**Re:** Remedial Action Work Plan Design Modification  
Queensboro Lanes Site  
25-01 Queens Plaza North  
Long Island City, Queens, New York  
BCP Site No.: C241257  
Langan Project No.: 170652801

# Technical Memorandum

Option 3 is the selected remedial alternative. This alternative includes a plan for source removal, treatment via ISS, and containment. Figures 1 and 2 illustrate the selected alternate remedial approach in layout view and cross-section.

Figure Title  
**SELECTED REMEDIAL ALTERNATIVE (PLAN VIEW)**

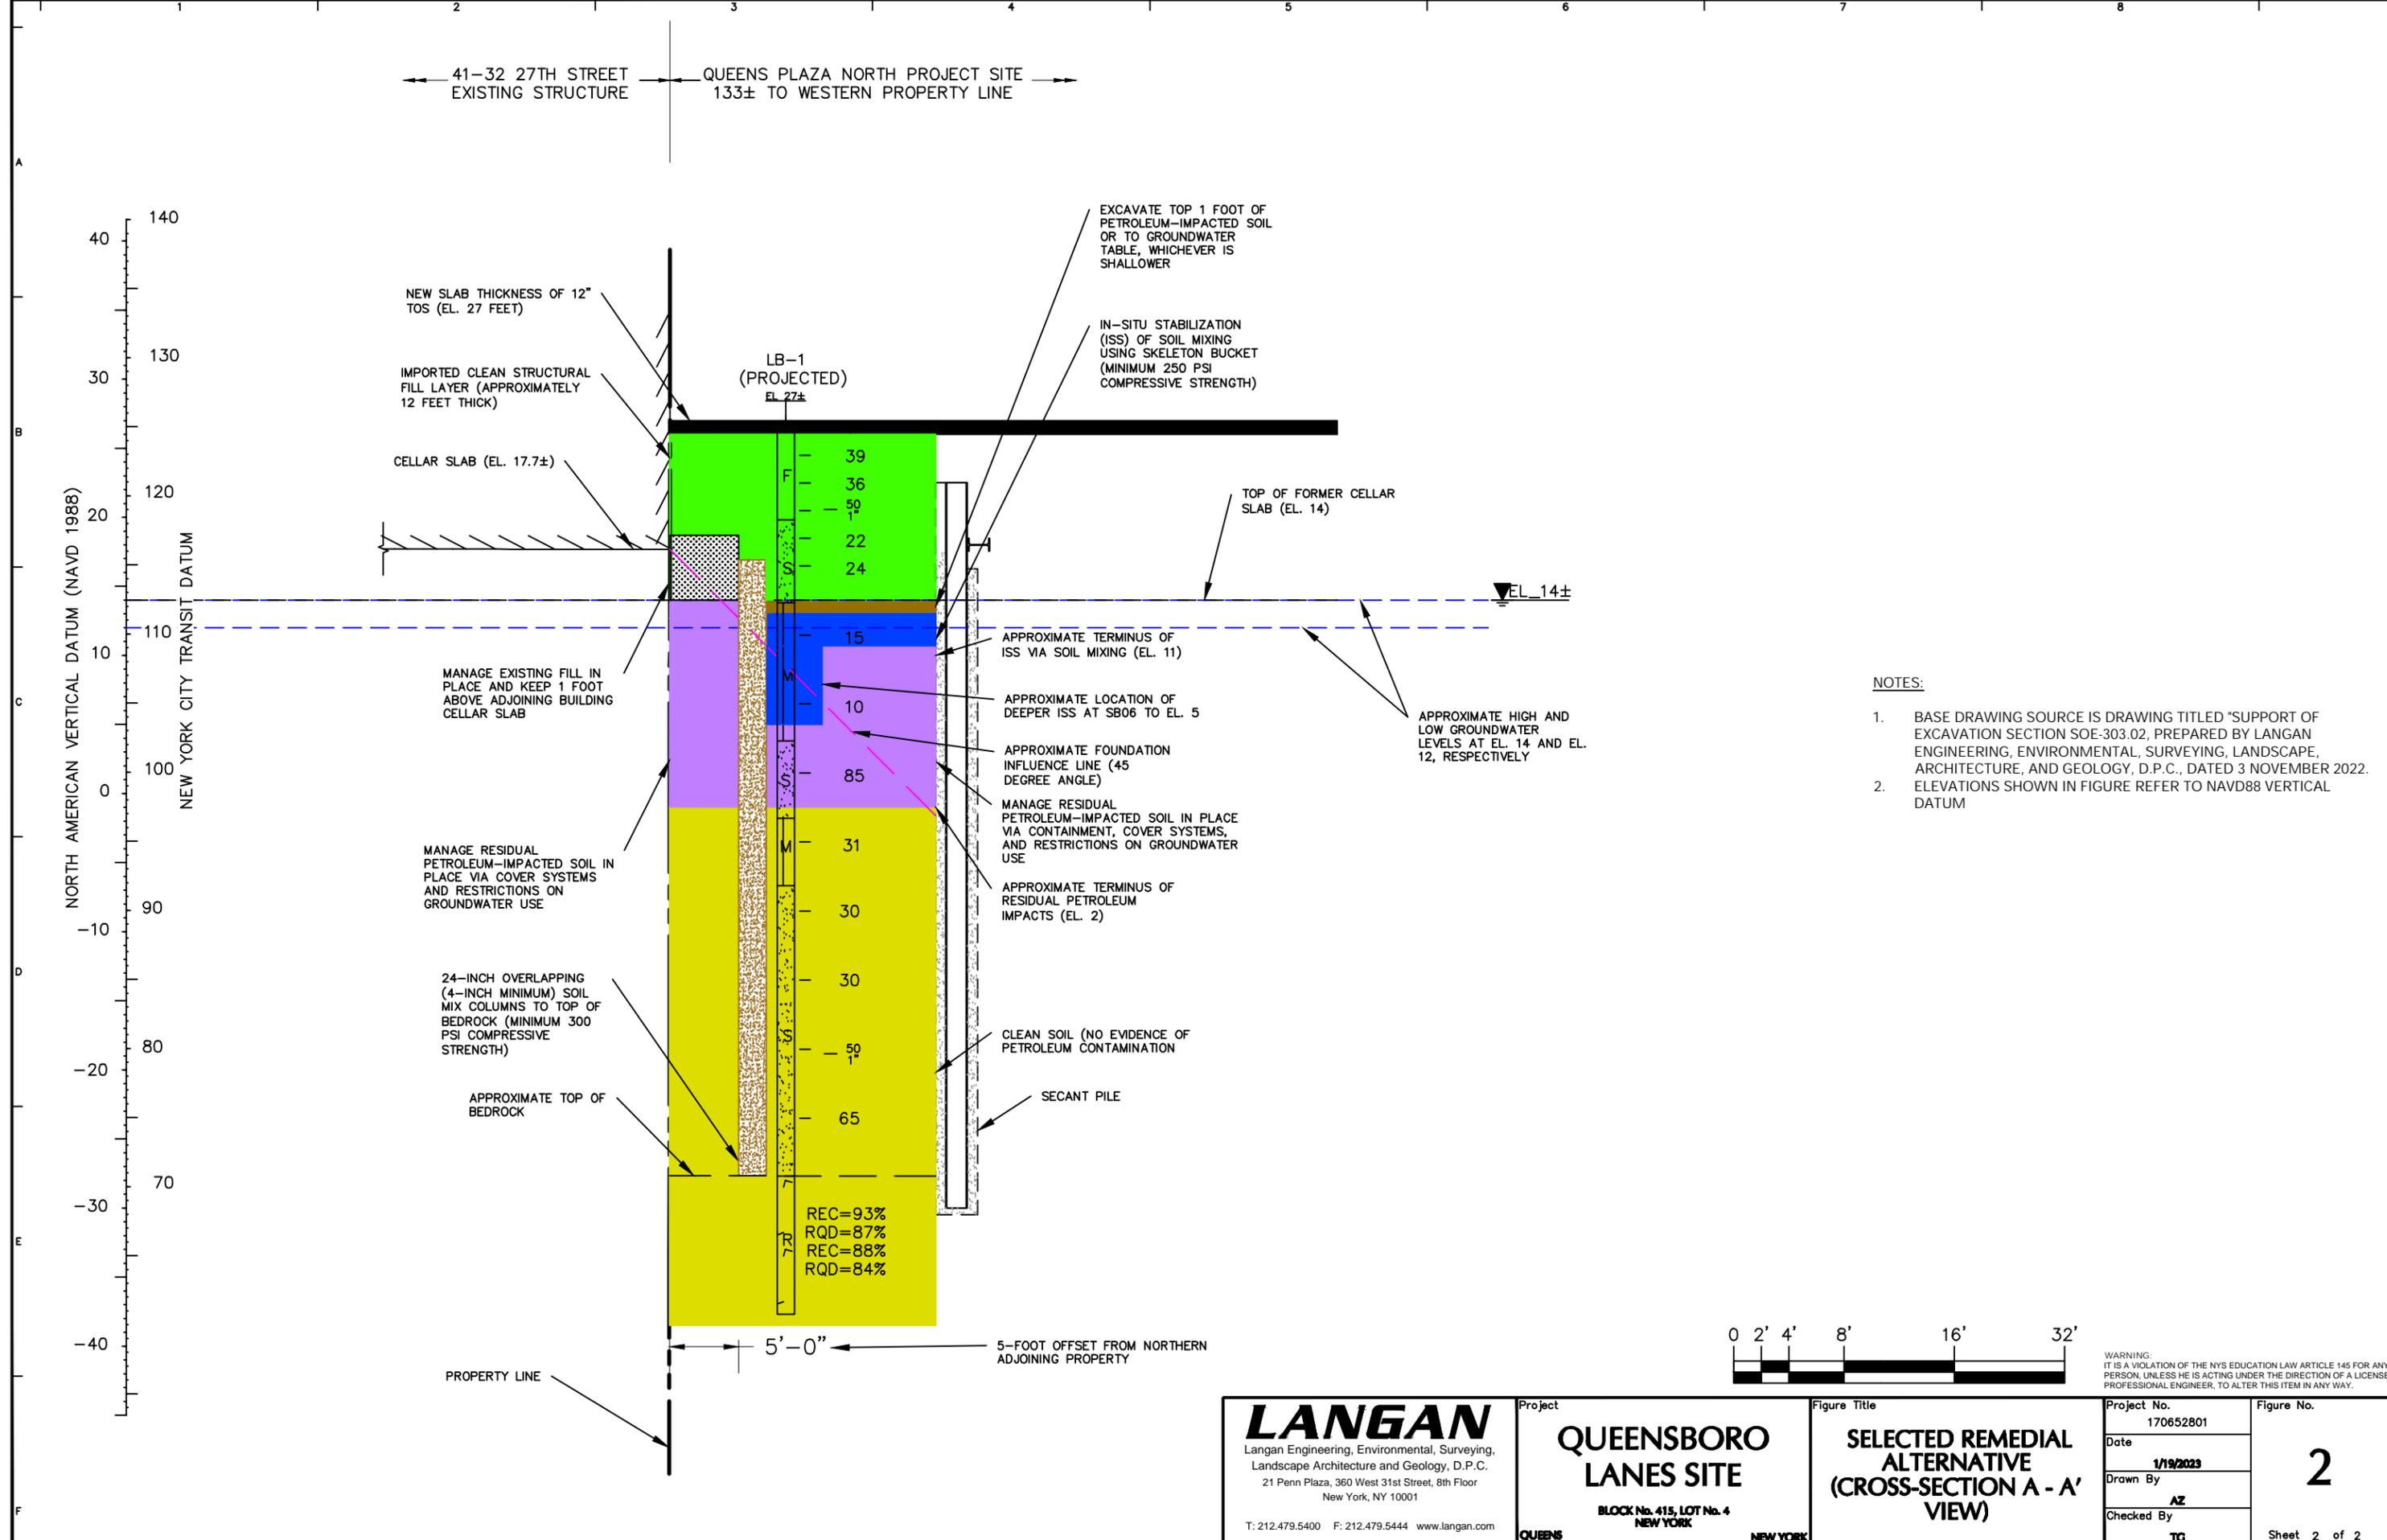
As described above, the plan includes installation of a subsurface containment barrier wall, consisting of about 85, 24-inch-diameter overlapping (4 inches of overlap) soil mix columns (using a dual paddle mixer attached to a top-mast drilling rig) advanced down to the top of the bedrock surface (about el -30). The barrier wall will run along the northern property line (about 5 feet away and parallel to the neighboring building) and turn south on both ends to connect with the secant pile SOE wall. The residual petroleum contamination within and below this buffer zone would be managed in place under a site cover system, consisting of imported clean fill and a concrete slab. Inside the barrier wall, remedial excavation of residual petroleum-contaminated soil (up to 1 foot or to the observed groundwater table [if present]) will be completed. After the remedial excavation, confirmation endpoint soil samples will be collected for laboratory analysis per the NYSDEC-approved RAWP to document final soil conditions. Sampling will be followed by additional treatment via ISS of the contaminated mass at the locations of borings SB6 and SB29 via soil mixing using a dual paddle mixer to about el. 5. The ISS at the two locations will consist of four, 24- to 28-inch overlapping and over-drilled (horizontally) soil mix columns creating an about 4-foot by 4-foot x 6-foot deep stabilized mass. The soil mixing would extend below the neighboring building foundation's influence line at SB6 only. After the localized deeper ISS, the remaining contaminated mass inside of the containment barrier wall will be treated via ISS via soil mixing using a skeleton bucket to about el 11. Care will be exercised through depth control to not cause soil disturbance below the neighboring building foundation's influence line. The ISS will stabilize the upper 2-3 feet of the remaining contaminated zone. One permanent groundwater monitoring well will be installed within the containment zone per the NYSDEC-approved RAWP to allow for least one round of post-remediation groundwater sampling to document groundwater conditions and assess the effectiveness of the remedy.
